10 Mb/s Single Twisted Pair Ethernet

10BASE-T1L PHY Control State Diagram

(Comment #584)

Steffen Graber
Pepperl+Fuchs

Changes (in red) to:
 Figure 146-14 – PHY Control state diagram (part a)

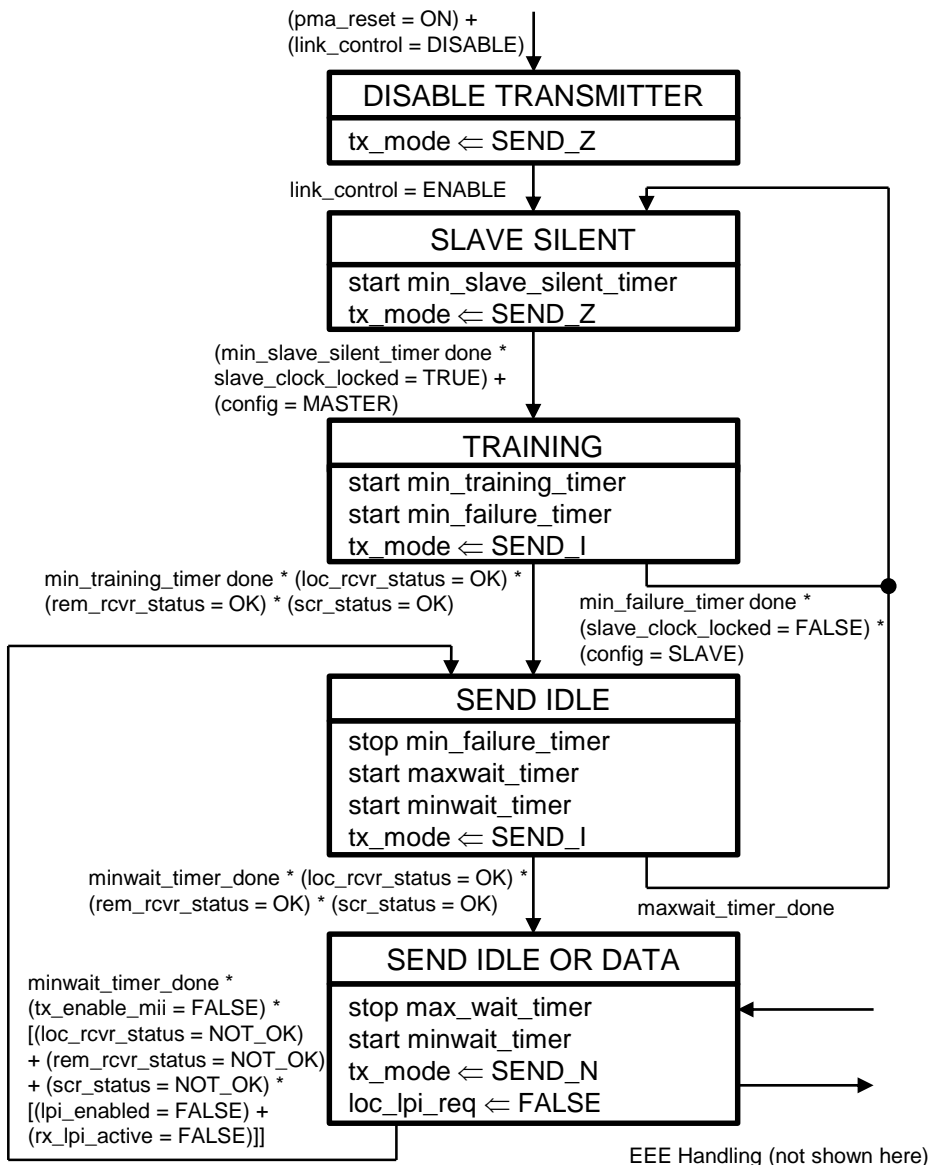
- Depending on the implementation the PHY Control state machine in D2.0, can run into synchronization issues, if FORCE mode is active. See presentation:

- Main reason for these issues is that both, Master and Slave PHY provide a “training_timer”, which limits the maximum time, a PHY may stay in training and if both timers are not synchronized, then it can happen, that for one PHY only a part of the training time remains, so that this PHY cannot finalize the training and therefore has to start training again.
- This condition may, depending on the implementation, persist for a longer time.
- To solve this issue, some changes in the PHY Control state machine are suggested.

This state machine can now be simplified by combining the Master and Slave training states (see next page).
